Piper Aircraft Corp.  
AD 81-11-02 R1  
Amendment 39-4222  
Effective Oct. 2, 1981  
Revises AD 81-11-02  
Recurring: No

**Airworthiness Directives; Piper Model PA-28R-200, PA-28R-201 and Model PA-28RT-201 Airplanes.**

**ACTION:** Final rule.

FIGURE 1  
AD 81-11-02

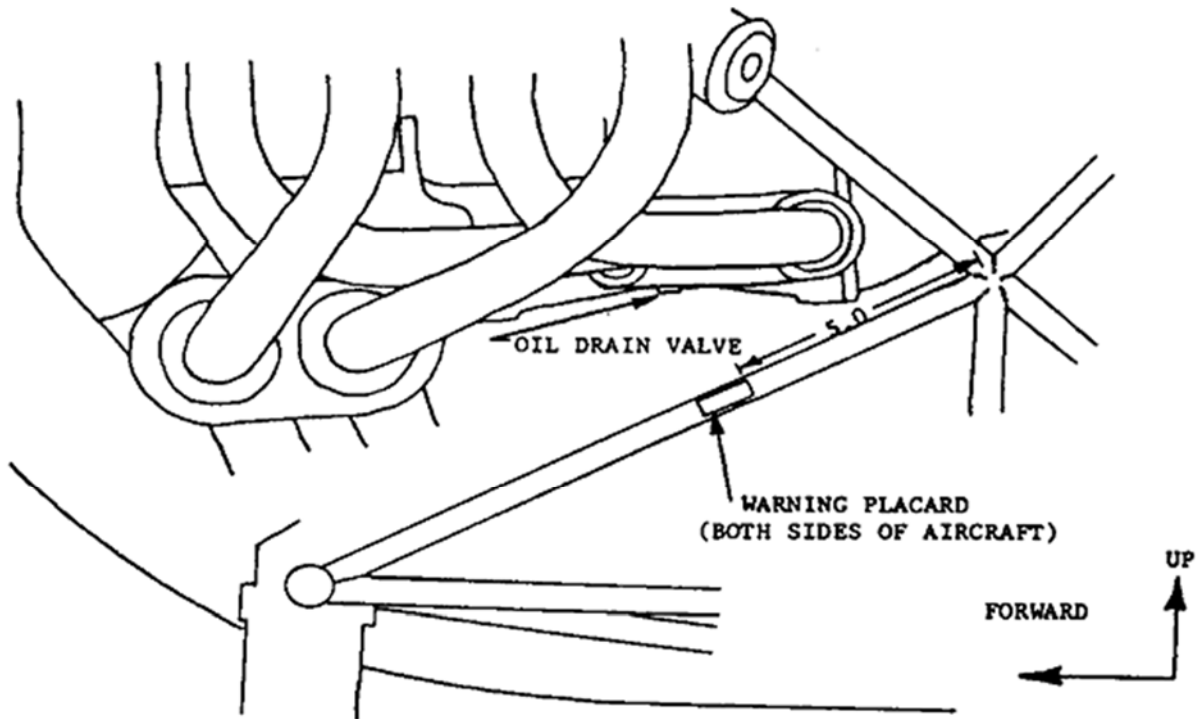
(a) Install two warning placards, one on each side, on the lower engine mount beneath the intake and exhaust tubes, in accordance with Figure 1. Use Piper Part No. 87369-26V which reads:

"CAUTION

Unapproved Oil Drain Valves Can Cause Inadvertent Draining When the Gear is Retracted - Use Only Piper Approved Part"

FIGURE 2  
AD 81-11-02

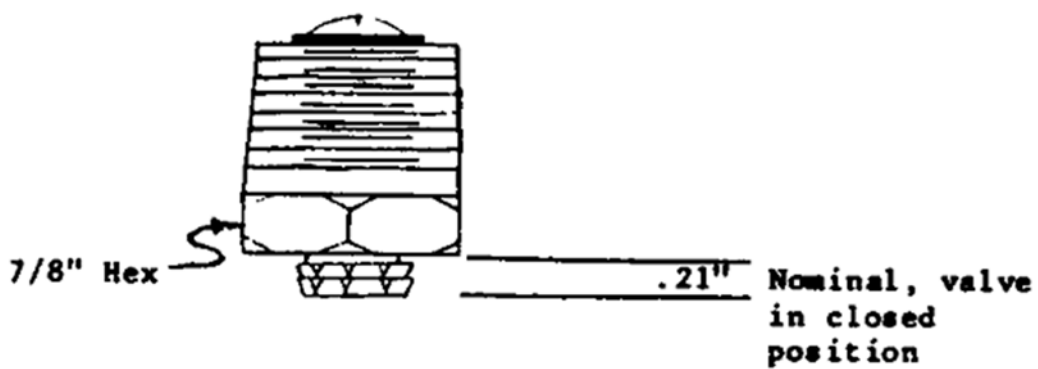
(1) Inspect the oil quick drain valve and insure that Piper Part No. 492-172V is installed and correctly safety wired. The correct valve can be identified by comparison with Figure 2. Also, the Number 1H50-1 may be visible on the hex.

(2) If an incorrect valve is installed, replace with Piper Part No. 492-172V, and safety wire, using .032 safety wire.
